To: Palmyra Plan Commission

From: Brad Vowels-Katter, Zoning Administrator

Subject: General Development Plan (GDP) for Westfield Planned Unit Development (PUD) Mixed Residential and Commercial Development for Parcels 171-0516-2722, 171-0516-2811, and 171-0516-2814

Date: July 10, 2025, Updated July 31, 2025 (Updates noted in Green)

Figure 3: Westfield Development Phasing Diagram

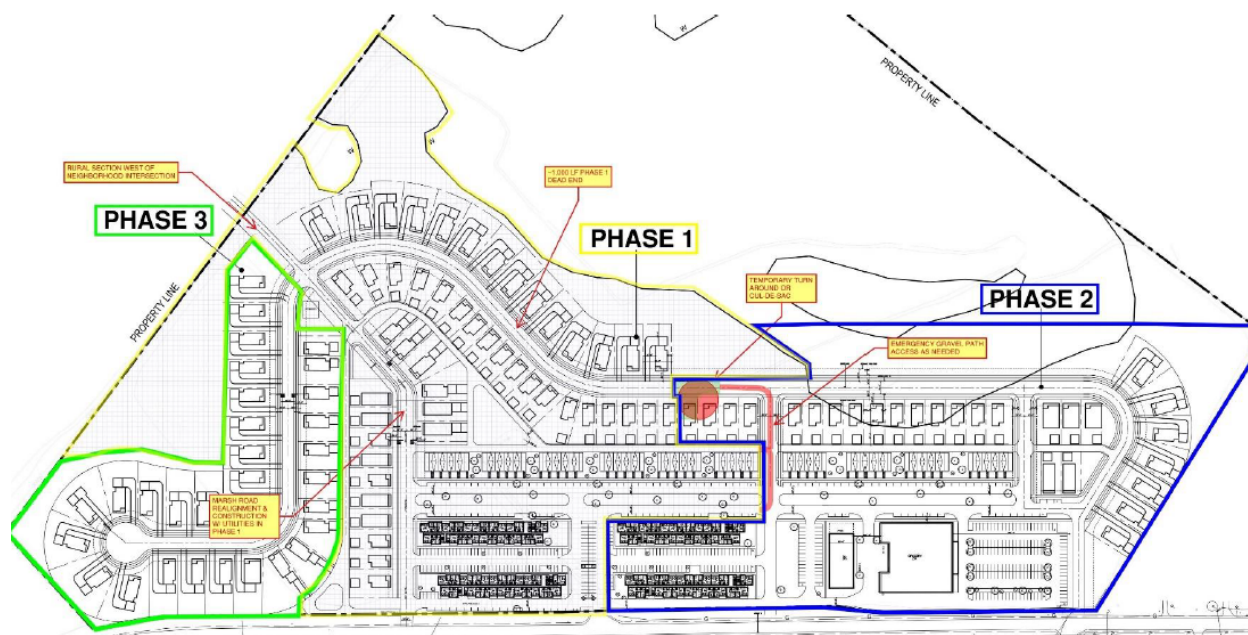
The applicant has outlined a phasing diagram of the site. A general phasing timeline should be proposed by the developer with general timeframes expected for construction.

Figure 4: Public and Private Streets and Parks/Open Space and Stormwater Management Diagram

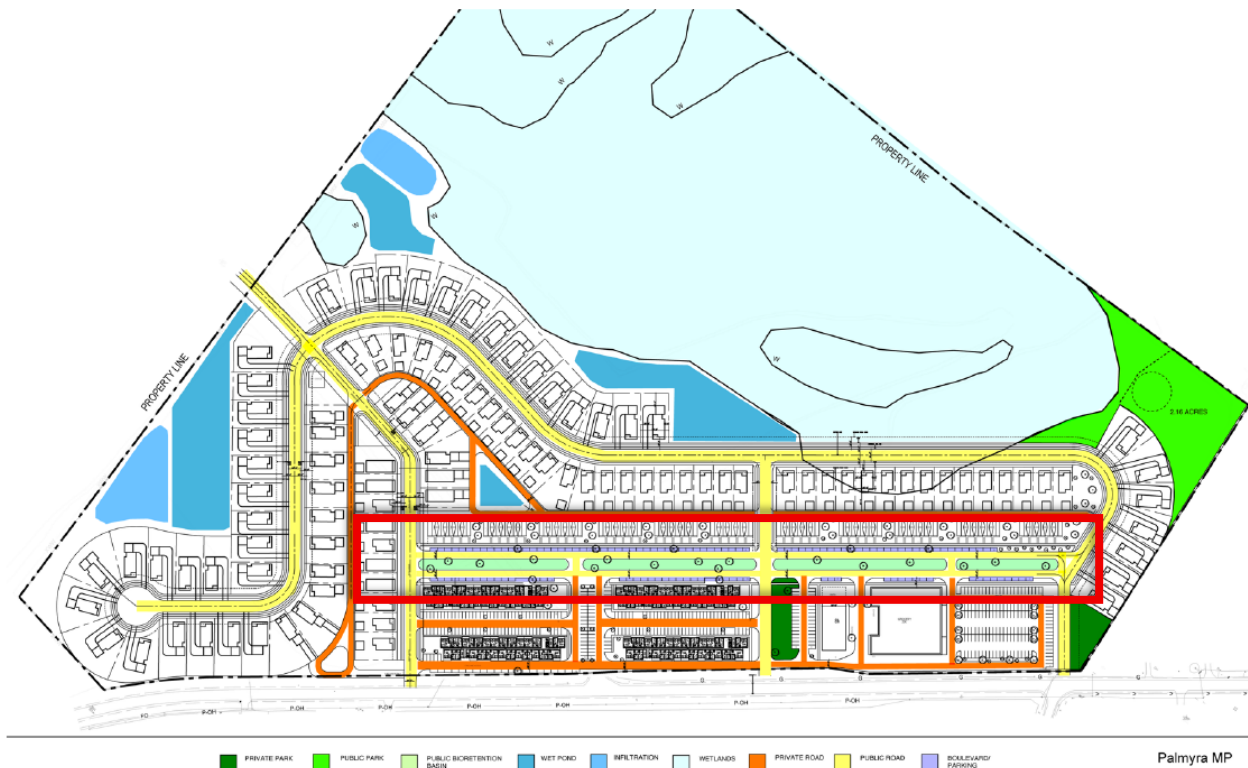
- 1. Public vs Private Streets:** Prior discussion with the Village has indicated a desire to keep the boulevard as a private street. The diagram included on page 13 of the GDP shows proposed public & private street designation. Indicating the boulevard separating the commercial lots from the townhomes as a public road where it was denoted as a private street in previous plans. Further discussion between the Village & Applicant is required to confirm status of the boulevard prior to final recommendation of the GDP for Board approval. Providing the central boulevard as a public street creates a few issues that need to be addressed before approval of the GDP or have the boulevard maintained as a private street.

- a.** The intersection(s) at the far north-eastern end of the development do not meet the minimum separation requirements per Village Ordinance.
 - b.** Parking spaces along the boulevard can no longer be counted in overall totals to satisfy the parking requirements for residential or commercial off-street parking.

- c.** Current road alignment with one-way traffic on either side of a stormwater infiltration basin creates road maintenance issues and safety considerations that the Village would not presently accept responsibility for.

1. No other permit or approval is waived or deemed satisfied except for the approval of the PUD-GDP provided herein.
2. Should the boulevard be dedicated to the public, further refinement within the GDP to resolve concerns outlined below shall require approval by the Village Engineer and Zoning Administrator and at least the following issues shall be resolved prior to the final approval of the GDP:

- a. Minimum separation distances for the intersection(s) at the far north-eastern end of the development.
 - b. Parking spaces and bump-outs along the one-way boulevards

- c. Current road alignment and functionality between one- and two-way transitions
3. The GDP shall be updated to correct any exhibits, gaps, and omissions related to the Zoning Administrator and Village Engineer evaluation along with items identified by Plan Commission.
